UNITED STATES PATENT AND TRADEMARK OFFICE

APPLICATION NO.	FILING DATE	FIRST NAMED INVENTOR	ATTORNEY DOCKET NO.	CONFIRMATION NO.
10/058,603	01/28/2002	Jorg Hein	4780-21	4012

Office Action Summary

INVENTOR:
ADRIAN GOTTFRIED OFFENBROICH

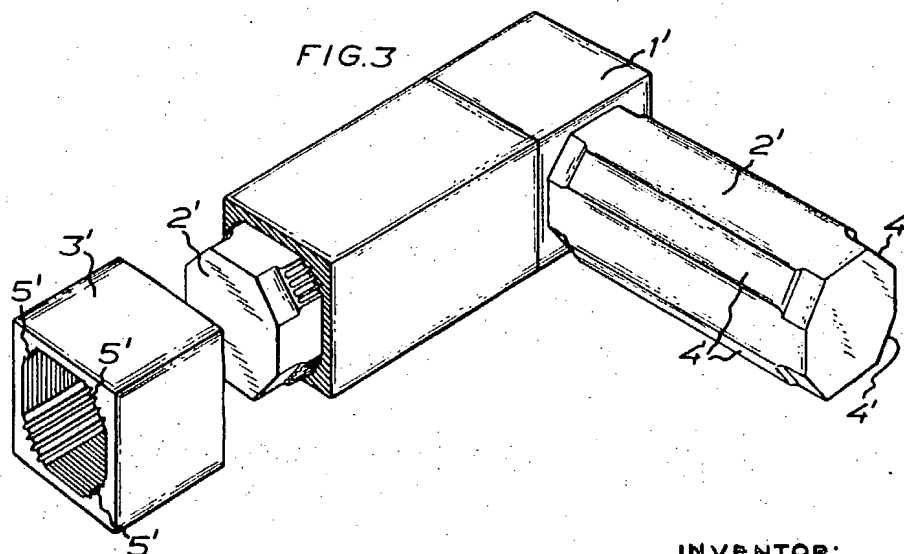
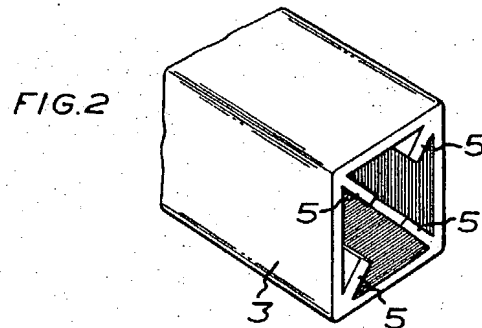
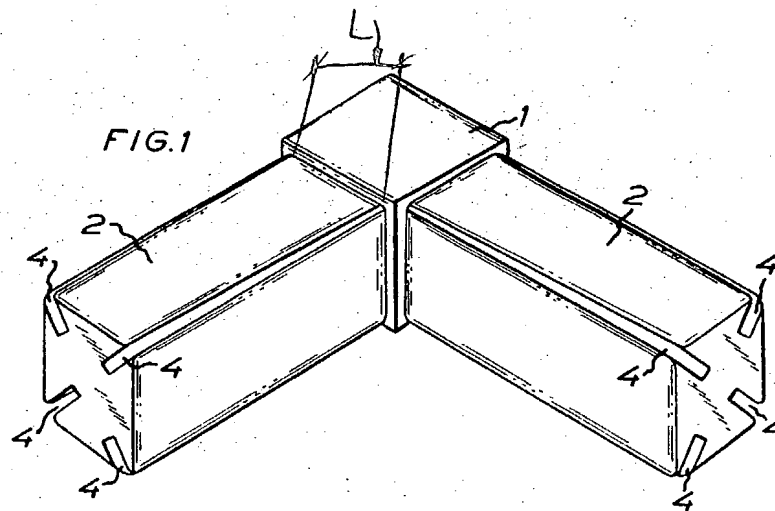
the frame (3,3') wholly surrounds the push-fit body (2,2'), column 2, lines 54-56 and column 3, lines 35-39. The push-fit body (2,2') further contains lengths (L) of the sidewalls (S) of the frame members (1,1',3,3'), see the enclosed marked attachment. Regarding claim 14, the push-fit body (2,2') forms a corner of the frame (1,1',3,3'). In reference to claim 19, the push-fit body is arranged to project out from the side wall (S) of the frame (1,1',3,3') in an X-direction.

KREIS. As detailed above, OFFENBROICH discloses the basic claimed connecting element except for the use of a frame bracket. KREIS teaches that it is known in the art to provide a connecting element (3) with a frame bracket (11). Hence, it would have been obvious to one having ordinary skill in the art to provide the parallel side walls (S) of connecting element of OFFENBROICH with the frame bracket of KREIS in order to provide the connecting element with a means for attaching other device thereto. In reference to claim 16, the frame bracket (11) of KREIS includes arms (A) aligned with the side walls of the frame (3), see the marked attachment.
